Proposed Drive-Thru Coffee Shop Redevelopment,
Victoria Retail Park, Victoria Street, Bury

Technical Note

3704424

Report Number:	3704424-TN
Report Title:	Proposed Drive-Thru Coffee Shop Redevelopment, Victoria Retail Park, Victoria Street, Bury
Client:	Lion Share Properties Ltd
Date:	10 March 2025
Status:	-

Proposed Site Layout

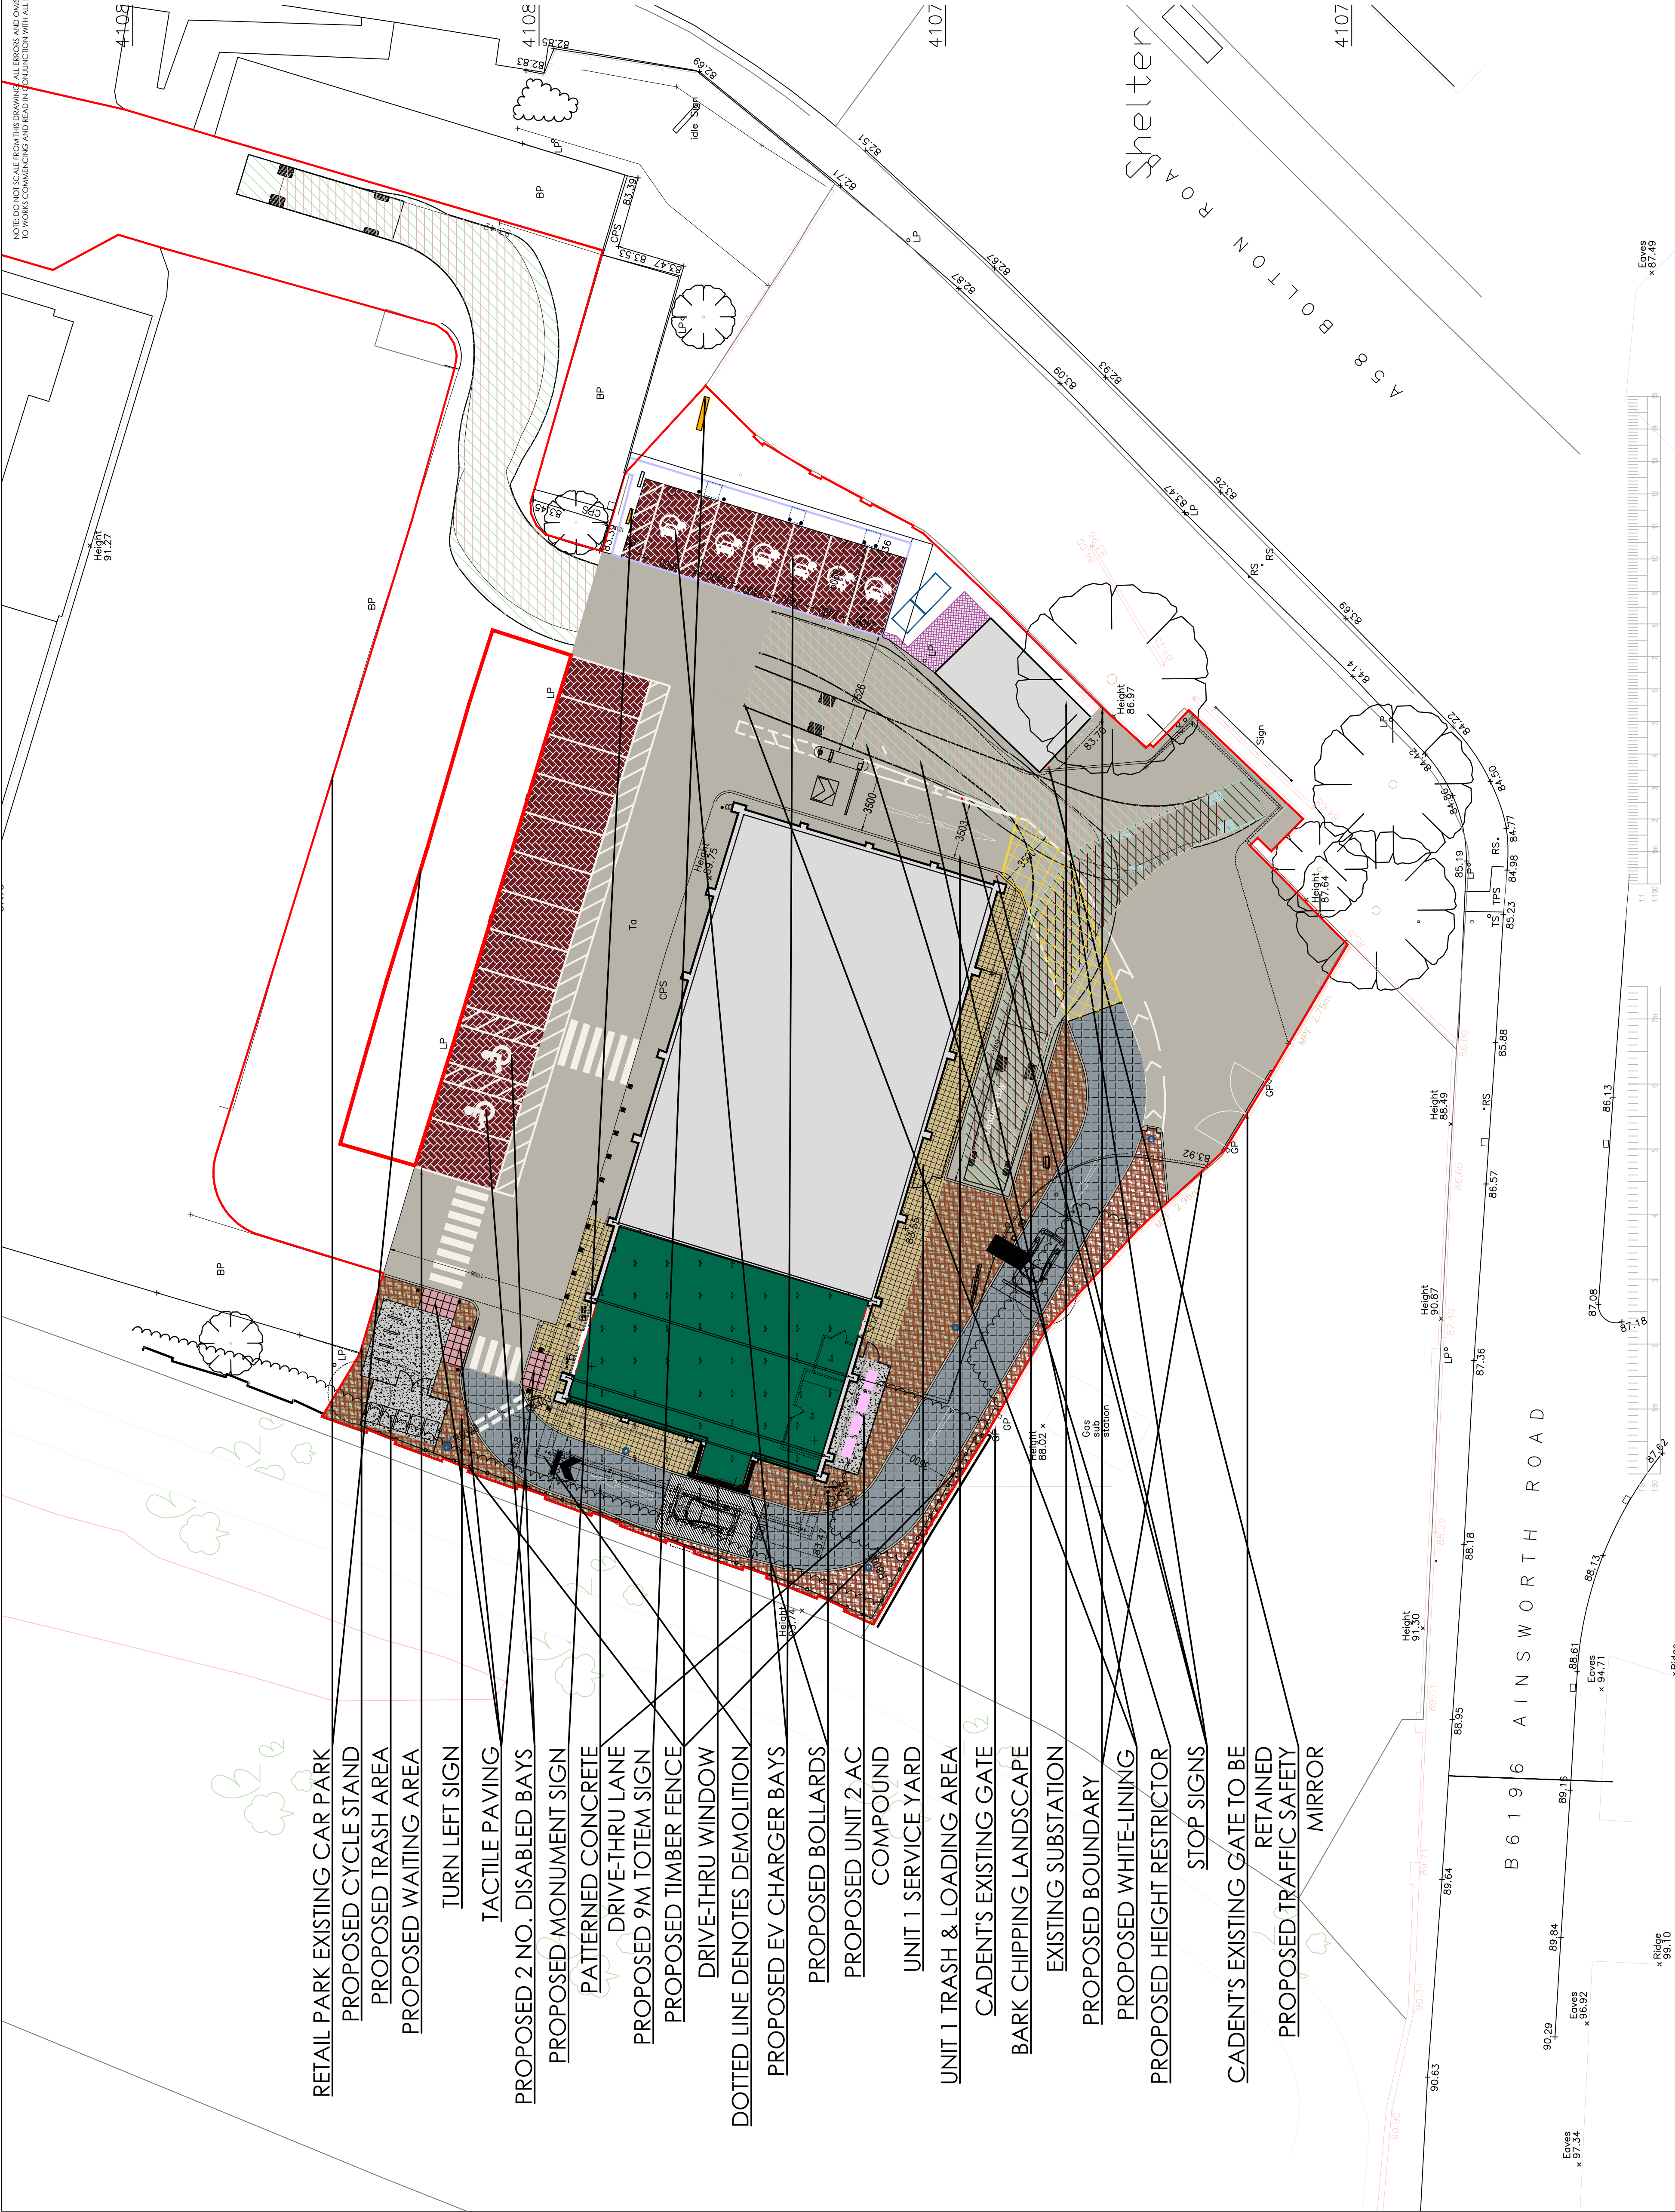
- 2.3 Discussions held with the LHA during the meeting on 10th January highlighted that the LHA's key concern was the loss of the existing servicing arrangement for both Unit 1 and 2 at the site.

- 2.4 During the meeting, DTP presented a potential design option of incorporating a delivery bay to the rear of the units to serve both units. The design incorporated hatching through the drive-thru lane to ensure there was a clear route for delivery vehicles to the servicing bay. The LHA acknowledged that the delivery bay was acceptable should it be shown that a 10m rigid vehicle was able to access and egress the bay.

- 2.5 As part of the revised Transport Assessment, the updated layout design was included, with swept path analysis for a 10m rigid vehicle shown. For the avoidance of doubt, the updated site layout plan is shown at **Appendix 1**, with the swept path analysis for the 10m rigid vehicle shown at **Appendix 2**.
